Access Compliance Report Public Rights-of-Way (Pedestrian Signals)

Main Street: **ORANGE_AVE** Cross Street: **BROOKHURST_ST** Location: **NW**

ADA ID: **SGRK210927122204** Signal Type: **One Push Button-Non APS** Overall Compliance: **No** Severity Scores: **BTN 1: 25** **BTN 2: N/A** **No BTN: N/A**

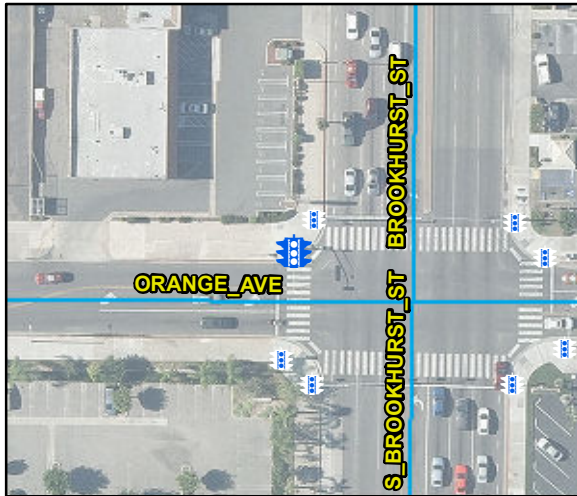
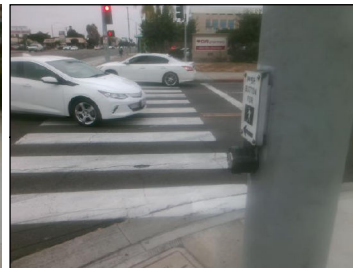
OC Std/PROW: **R404.2**

Possible Solutions: Remove and Replace Clear Space.
